SUBJECT: Forwards info re containment isolation & leak testing, per
 841221 request. Reasons why main steam lines not vented
 during Type A testing discussed. Info will be included in
 Amend 17 to FSAR.

Re: Nine Mile Point Unit 2
Docket No. 50-410

Enclosed for your use is information regarding Containment Isolation and Leak Testing for Nine Mile Point Unit 2 which was discussed with the Nuclear Regulatory Commission staff during a telephone discussion on December 21, 1984.

The enclosed information will be included in Final Safety Analysis Report Amendment 17.

ISOLATION VALVE ARRANGEMENT
 FOR PENETRATION Z-5A, B, C, AND Z-15
 SHEET 4 OF 43

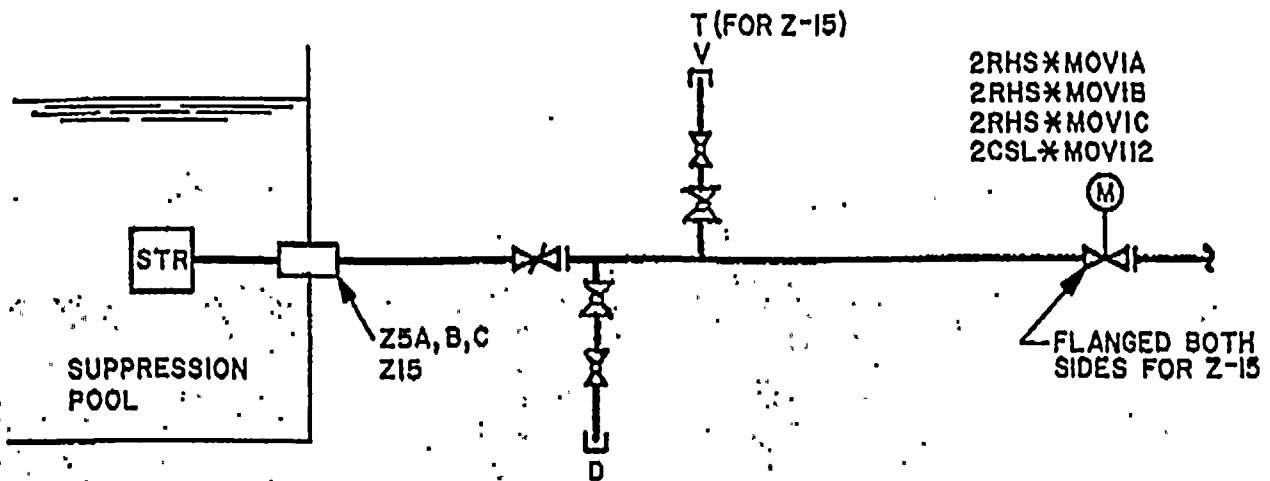
Specifically, the staff had requested a further explanation of why the main steam lines were not vented during Type A testing. This explanation has been inserted on FSAR page 6.2-86. In addition, we informed the staff that we would be adding a second valve to several test lines that previously had only one valve and a threaded pipe cap. This commitment is being incorporated in the FSAR by removing footnote 35 on Table 6.2-56 and revising Figure 6.2-70 Sheets 4, 5, 8, 12, 15 and 36 to show the two valves.
